Item Name: Replacement Skidtube, Low & High Gear with Standard Wearplates Fits LH or RH

DRAWING NO. D2650	TITLE 206/407 SKIDTUBE ASSEMBLIES	REV. F	DART AEROSPACE LTD ENGINEERING ORDER		D.E.O. NO. D2650-F-1	SHEET NO. SHEET 1 OF 1	SCALE NTS
DRAWN <i>[Signature]</i>	CHECKED A.P.	MFG. APPR. <i>[Signature]</i>	APPROVED <i>[Signature]</i>		DE APPR. <i>[Signature]</i>		
DATE 12.10.12	DATE 12.10.22	DATE 12.10.22	DATE 12.10.22		DATE 12.10.22

CHANGE C'BORED WELDED CROSSBOLT SPACERS TO SWAGED SPACERS

DETAIL G

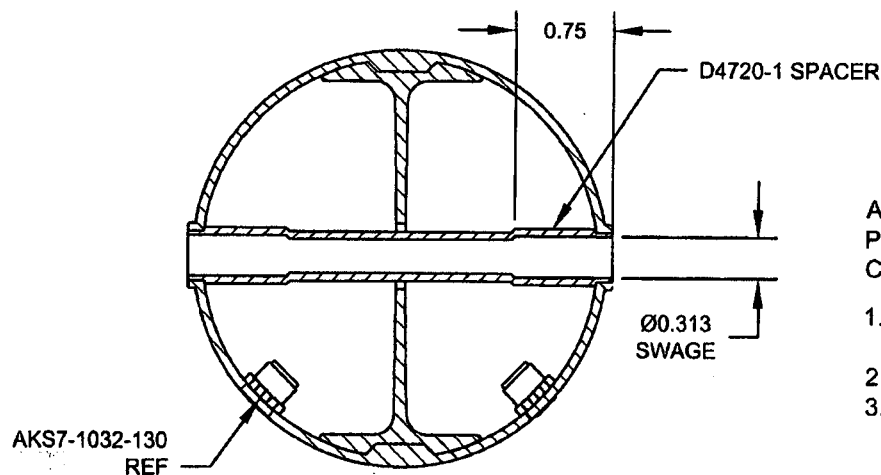
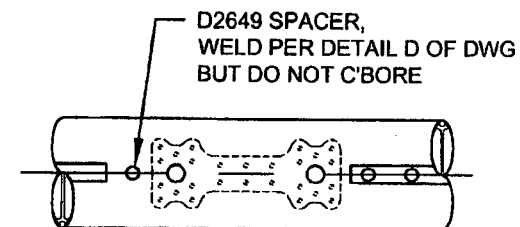
WAS:

17	18	19	23	D2649	CROSS BOLT SPACER
----	----	----	----	-------	-------------------

ADD DETAIL G BELOW, WHICH IS THE SAME SECTION VIEW AS DETAIL D OF DWG.
C'BORED HOLES ARE **NOW SWAGED** PER DETAIL G BELOW. FOR THE Ø0.375 HOLE THAT IS NOT C'BORED, WELD PER DETAIL D OF DWG (SEE AMENDED DETAIL B FOR REFERENCE).

FOR Ø0.375 HOLES ONLY
FOR HOLES THAT ARE CURRENTLY C'BORED ONLY
NOT TO SCALE

AMENDMENT TO DETAIL B
NOT TO SCALE
